**Class 2 Permit Modification Request**

**Waste Characterization Updates and Other Process Improvements**

**Waste Isolation Pilot Plant  
Carlsbad, New Mexico**

**WIPP HWFP #NM4890139088-TSDF**

**Figure G-2**  
**WIPP Traffic Flow Diagram**

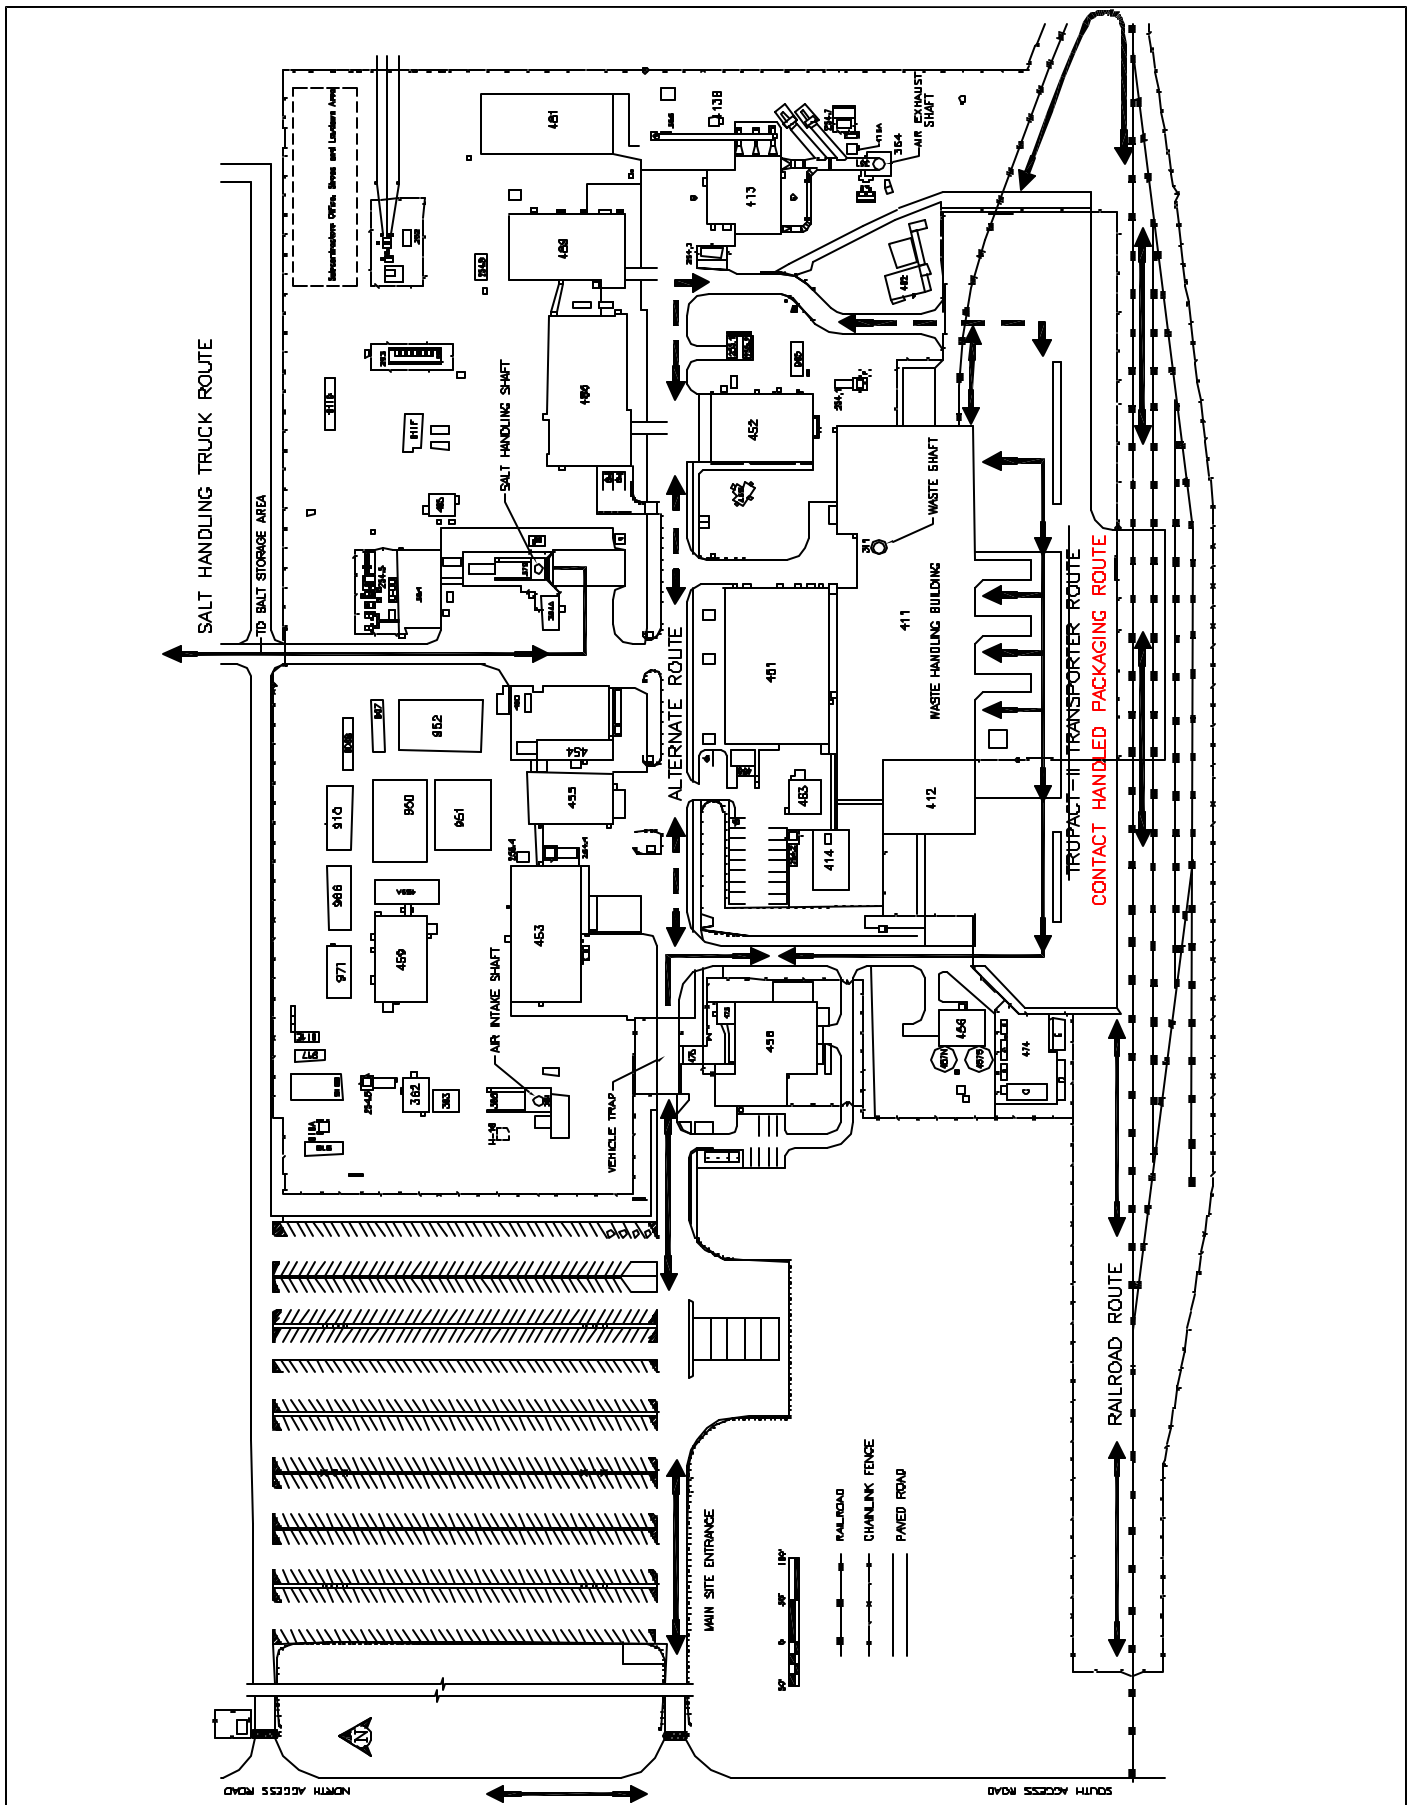
Access to the facility for personnel, visitors, and trucks carrying supplies and TRU mixed waste is provided through a security checkpoint (vehicle trap). After passing through the security checkpoint, ~~TRUPACT-II~~ TRU mixed waste transport trucks will normally turn right (south) before reaching the Support Building and then left (east) to park in the parking area HWMU just east of the air locks (Figure G-2). Outgoing trucks depart the same way they arrived, normally out of the west end of the parking area, north through the fence gate and out through the vehicle trap. An alternate inbound route is to continue straight ahead from the security checkpoint to the second road and to turn south to enter the truck parking area. The alternate outbound route is also the reverse of this route. Salt transport trucks, which remove mined salt from the Salt Handling Shaft area, will not cross paths with TRU mixed waste transporters; instead, they will proceed from the Salt Handling Shaft northward to the salt pile. Figure G-2 shows surface traffic flow at the WIPP facility.

**Figure M1-8a**

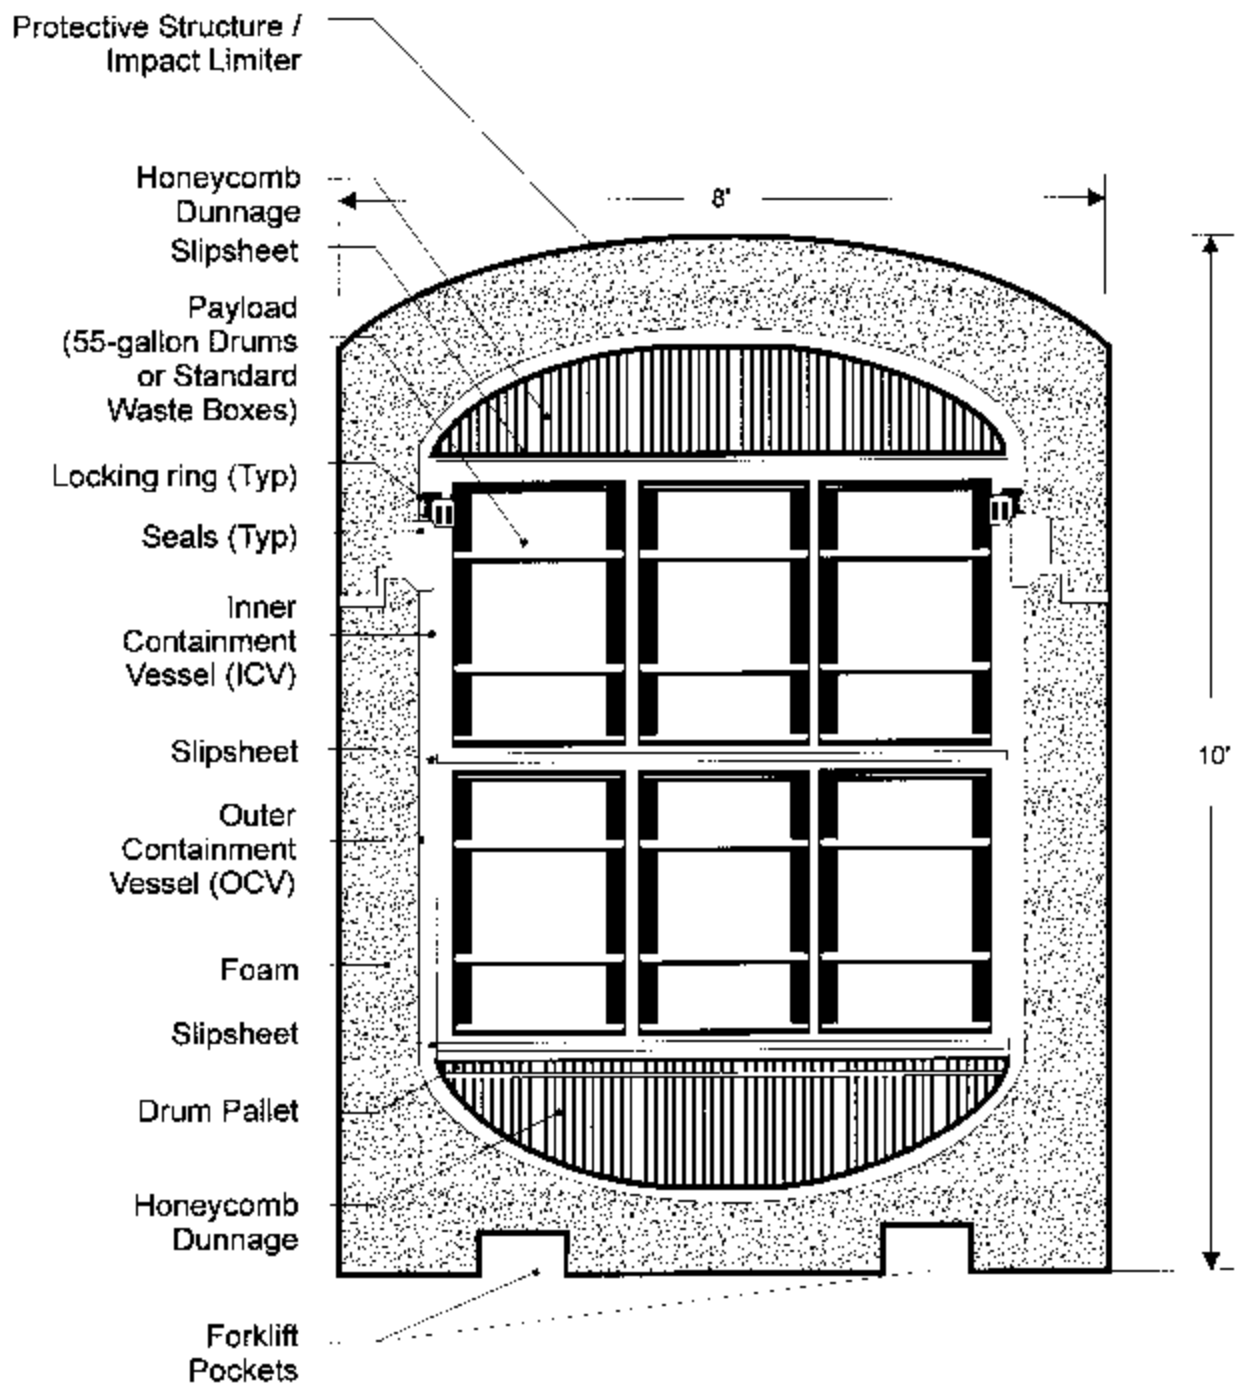
The TRUPACT-II (Figure M1-8a) is a double-contained cylindrical shipping container 8 ft (2.4 m) in diameter and 10 ft (3 m) high. It meets NRC DOT Type B shipping container requirements and has successfully completed rigorous container-integrity tests. The payload consists of approximately 7,265 lbs (3,300 kg) gross weight in up to fourteen 55-gal (208-L)

**Figure M1-8b**

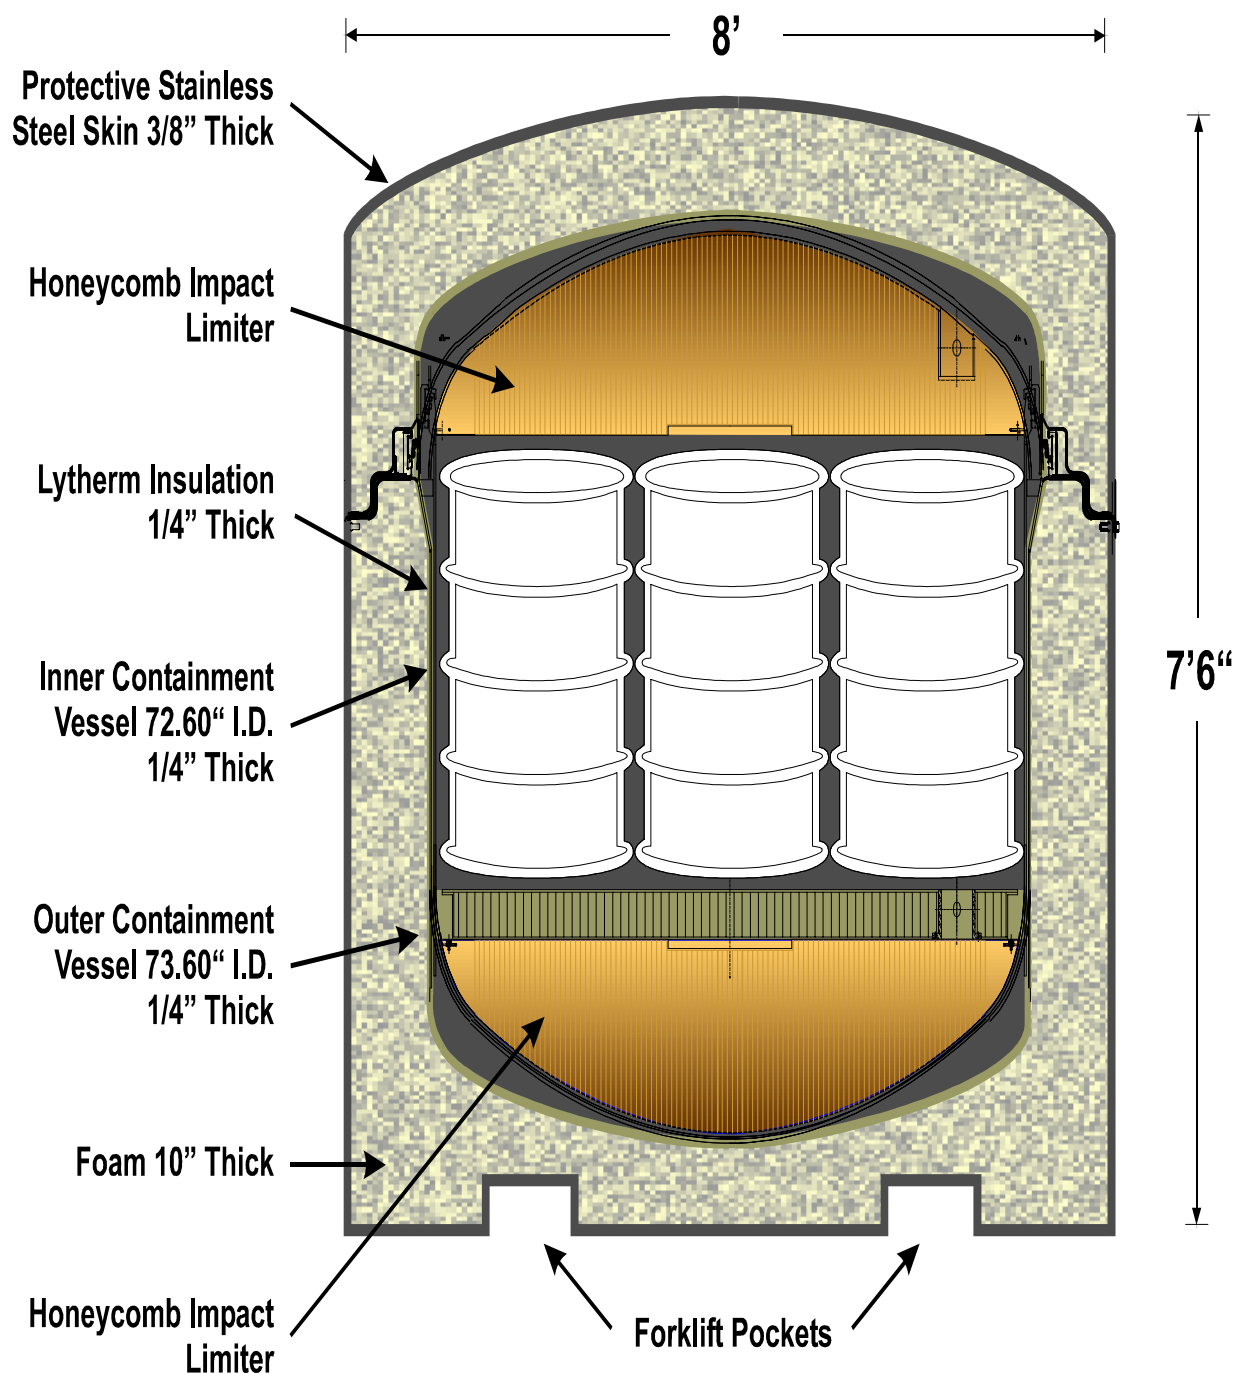
The HalfPACT (Figure M1-8b) is a double-contained right circular cylinder shipping container 7.8 ft (2.4 m) in diameter and 7.6 ft (2.3 m) high. It meets NRC Type B shipping container requirements and has successfully completed rigorous container-integrity tests. The payload consists of approximately 7,600 lbs (3,500 kg) gross weight in up to seven 55-gal (208-L) drums, one SWB, or four 85-gallon drums.

**Figure B-2**

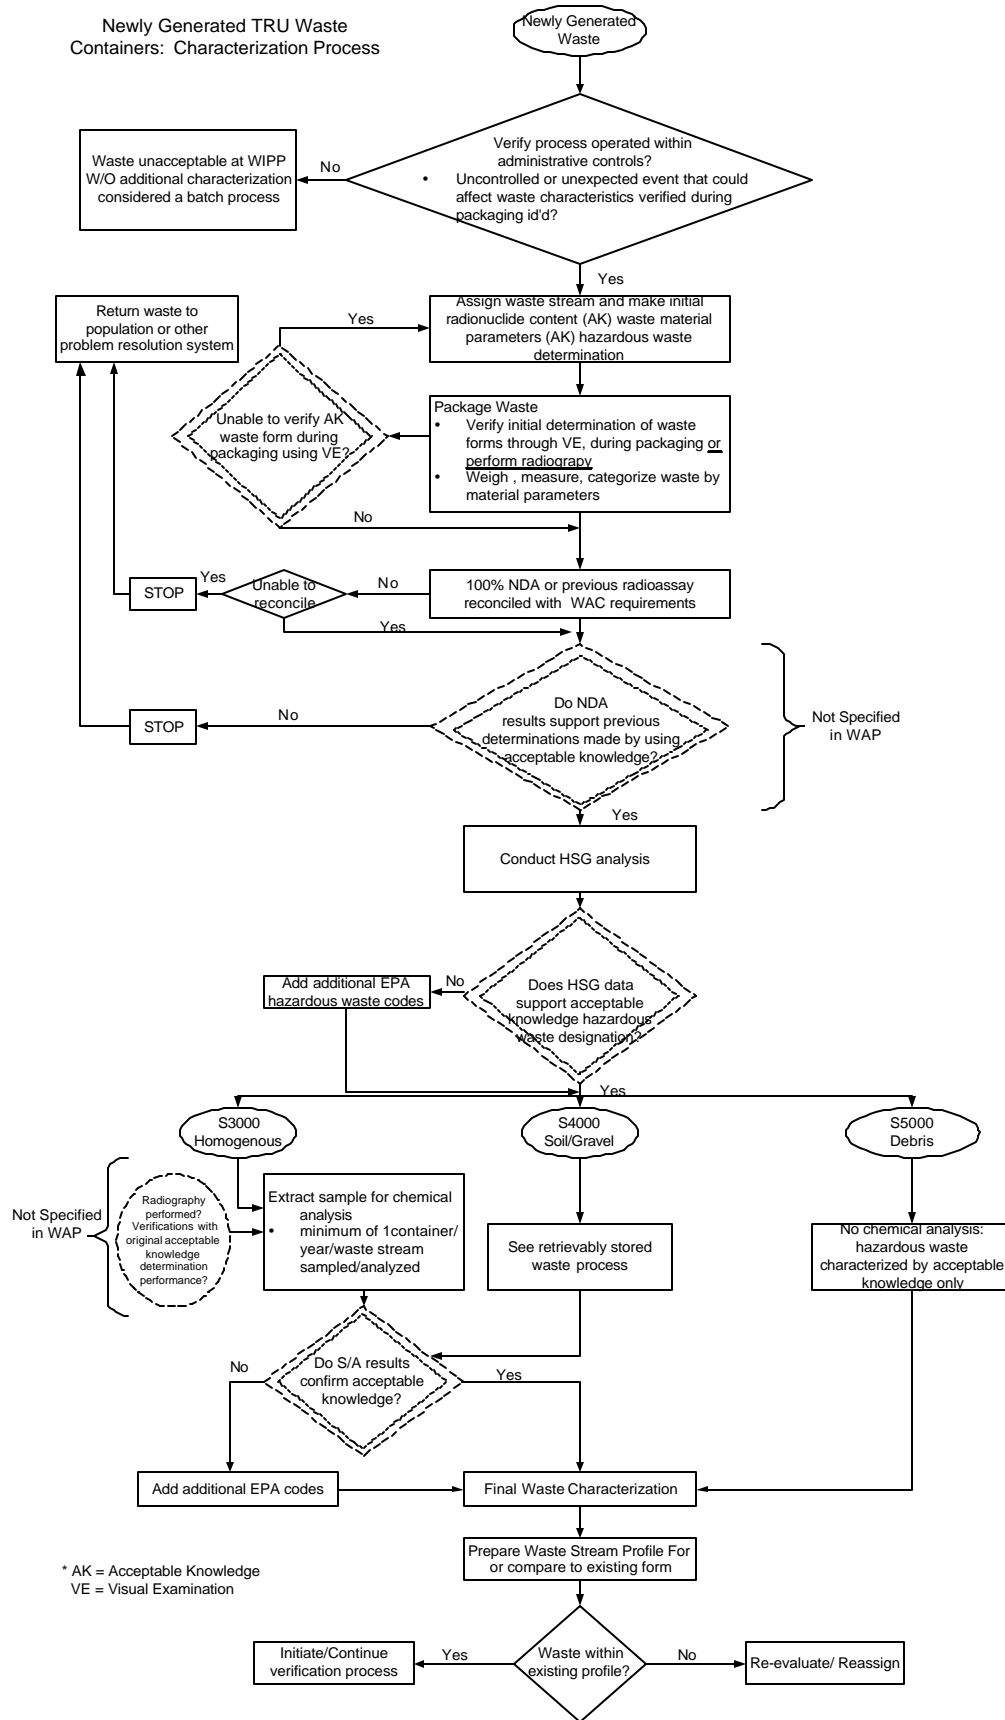
**This change updates Figure B-2 to allow the flexibility to use radiography or the VE technique for a newly generated waste.**
